## Department of Environmental Quality

Re: WQ: Variance Approval: 248-25-000014-VAR: 17091 Merced Rd; T.20S; R.10E; Sec. 13A; Tax Lot 14500; 0.51 Acres; Deschutes County.

**Schedule A – Laskey**  
**Variance Report - Special Conditions**  
**T 20S, R 10E, Sec: 13A, TL 14500**

Figure 3. Modified Bottomless Sand Filter Section

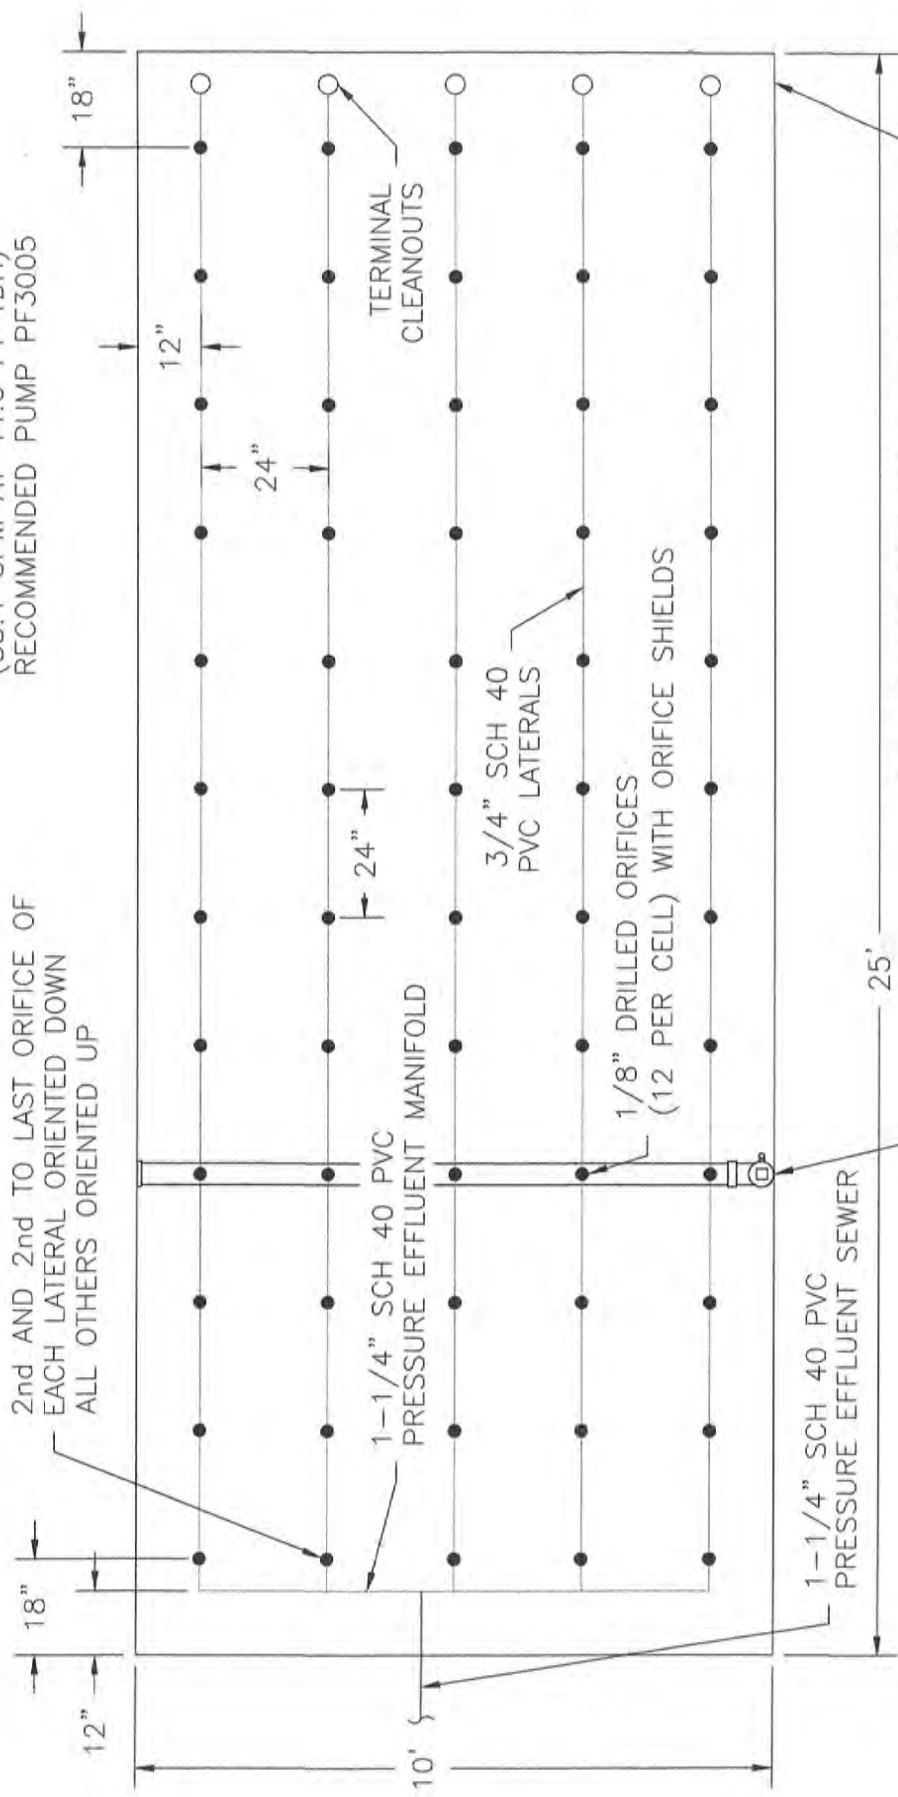
The proposed system seeks to overcome this limitation by elevating the modified bottomless sand filter in a manner that provides an additional 3 inches of separation (Figure 3). The sod and underlying sandy soil to a depth of 6 inches within the footprint of the sand filter will be excavated and replaced with sand filter media. An additional 9 inches of sand filter media (total of 15 inches) will be used to exceed the minimum 24-inch separation from shallowest water table depth standard by providing a total separation of 27 inches. Even if the water table rises above the level of the redoximorphic features, as occurred briefly during the spring 2000 monitoring for a previous site evaluation, this proposal would still provide a vertical separation of 25 inches. The rest of the sand filter will be “conventional” from there up, consisting of 6 inches of underdrain media, 24 inches of sand filter media, 6 inches of drain media (with the distribution laterals), filter fabric, and 6 to 9 inches of backfill.
